# Appleby Creek Flood Mitigation Municipal Class Environmental Assessment Addendum

## Public Open House

## Public Open House Appleby Creek Flood Mitigation Municipal Class Environmental EA Study Addendum

## 2019 Fairview Street Crossing Evaluation- Updated

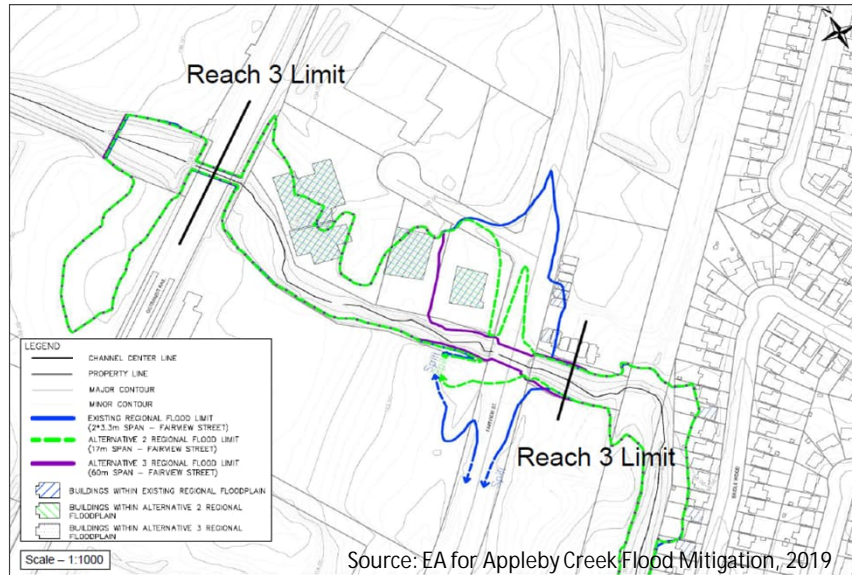
Revise Score from 7 to 8 - The 60 meter span would further decrease velocity and potentially decrease scour down potential in major storm.

Revise Score from 0 to 3 The disruption for reconstruction of the road in either case is similar in application and duration.

Revise Score from 0 to 3 The review of current cost estimates indicate the variance between the cost of a structure to convey a region storm vs a 100 year storm is <5% Additional cost may be off set by development charges.

Revise Total Score from 61 to 68

After applying the revised evaluation scores to the table, Alternative 3, the wider span structure becomes the preferred solution.

### 2024 MCEA Addendum Revised Solution (Option 3)

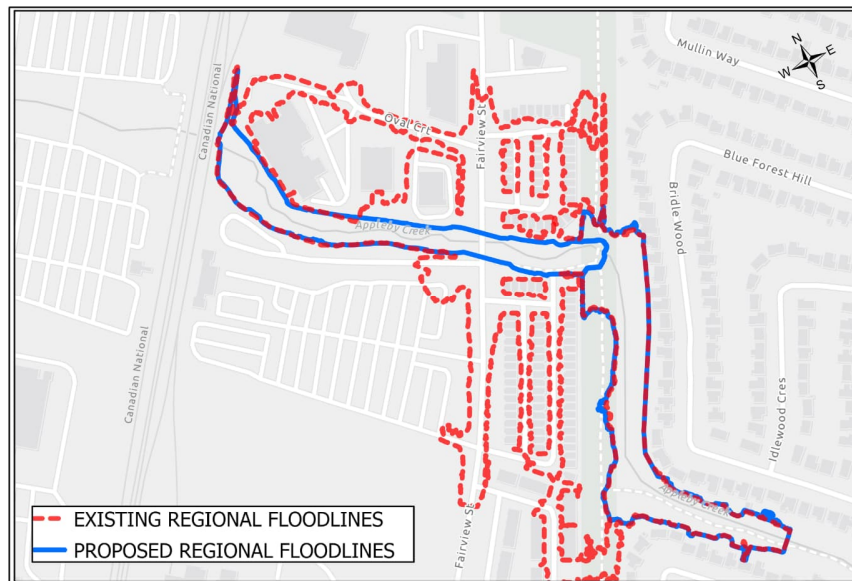
- Fairview Street crossing with a larger span structure to pass the 100-year storm and Regional storm conditions
- Minor grade elevation increase on the road surface depending on type of structure selected. Adjacent driveway and may require restoration.
- Existing and proposed buildings on Oval Court lands would be removed from within the Regional floodplain.
